**City of Portland, Maine - Building or Use Permit Application**

Job No: 2011-07-1759-ALTR	Date Applied: 7/20/2011	CBL: 380 - A - D - 014 - 001 - - - - -	
Location of Construction: 11 SUMMIT PARK AVE	Owner Name: LEON A & VALERIE MCKENZIE	Owner Address: 11 SUMMIT PARK AVE PORTLAND, ME 04103	Phone: 207-797-2159
Business Name:	Contractor Name:	Contractor Address:	Phone:
Lessee/Buyer's Name:	Phone:	Permit Type: <b>Building</b>	Zone: <b>R-3</b>
Past Use: Single family	Proposed Use: Same - Single family - build 1½ story 16' x 31.5 addition on the rear	Cost of Work: 50000.000000	CEO District:
		Fire Dept: <input checked="" type="checkbox"/> Approved w/conditions <input type="checkbox"/> Denied <input type="checkbox"/> N/A	Inspection: Use Group: R3 Type: SB (MURBEC) Signature:
Proposed Project Description: Addition for Kitchen, bath & Bedroom		Pedestrian Activities District (P.A.D.)

LEON & VALLERY McKENZIE RESIDENCE - ADDITION  
11 SUMMIT PK AVENUE  
PORTLAND, MAINE

Job 639023	Truss 001	Truss Type ATTIC	Qty 1	Ply 1	Job Reference (optional)
---------------	--------------	---------------------	----------	----------	--------------------------

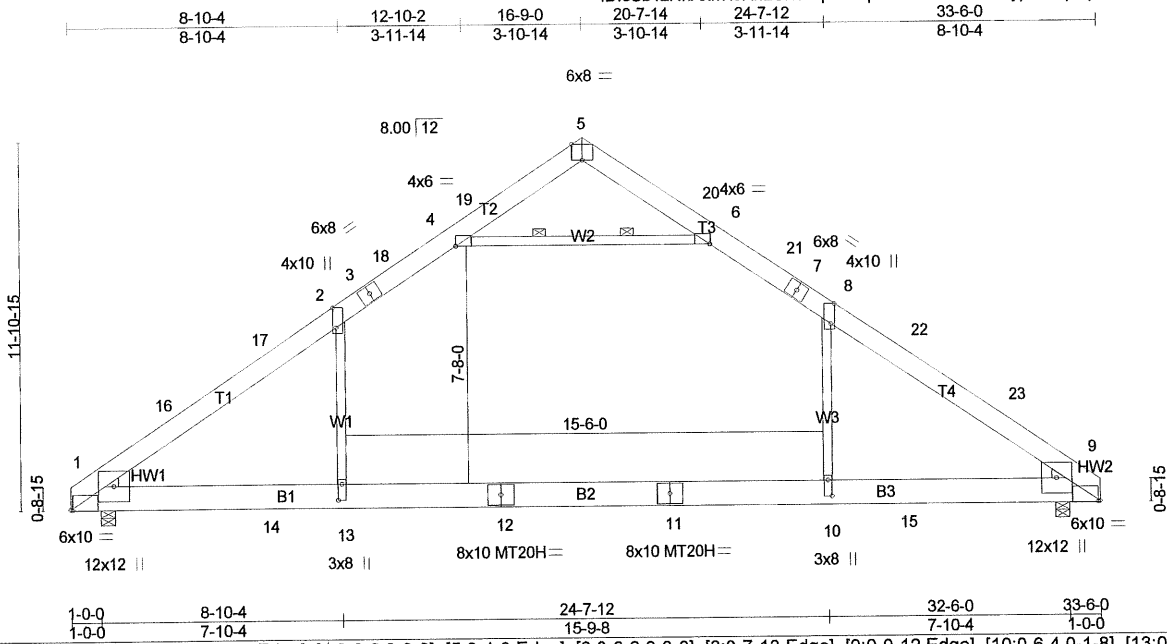
Are the overall height & dimensions staying the same with the truss design? Is the sheathing 5/8 inch with Asphalt? JGR.

That's a yes on everything
